## Product Change Notification: CAAN-02HDKP333

CCB 7395 Final Notice: Qualification of ANAP as an additional assembly site for ATSAM3U1EB-AU catalog part number (CPN) available in 144L LQFP (20x20x1.4mm) package.

# CCB 7395

### PCN #: CAAN-02HDKP333

## ASSH

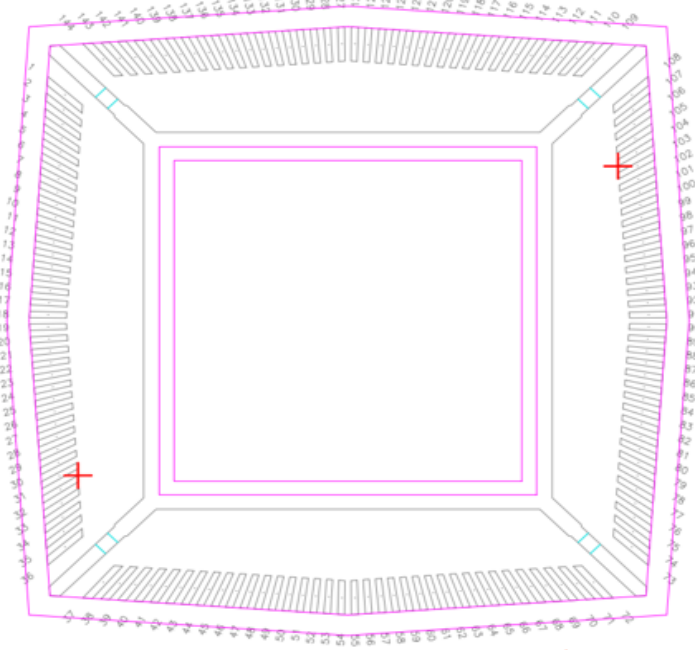
Lead Frame Material	C7025
Lead-Frame Lead-lock	None

## ANAP

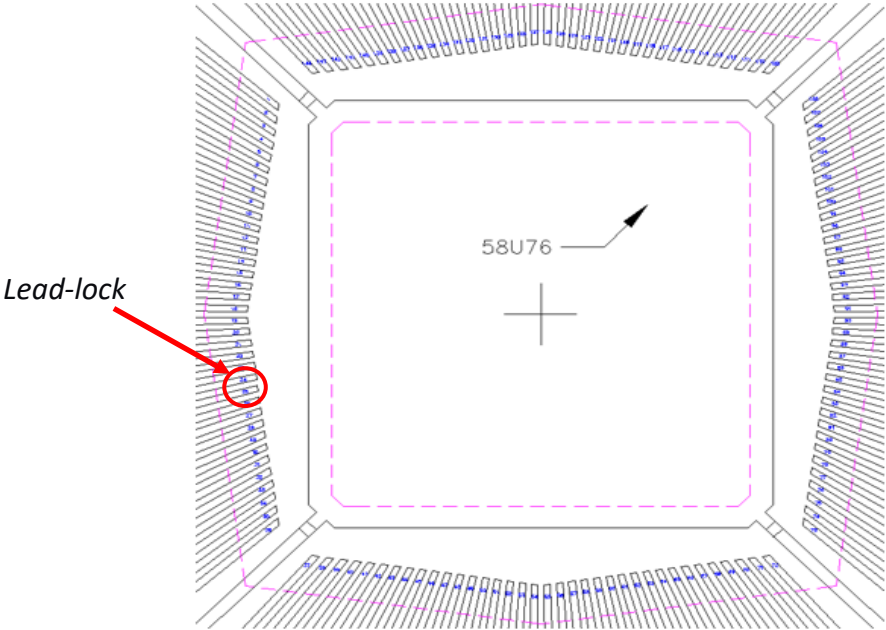
Lead Frame Material	C194
Lead-Frame Lead-lock	Locking Lug
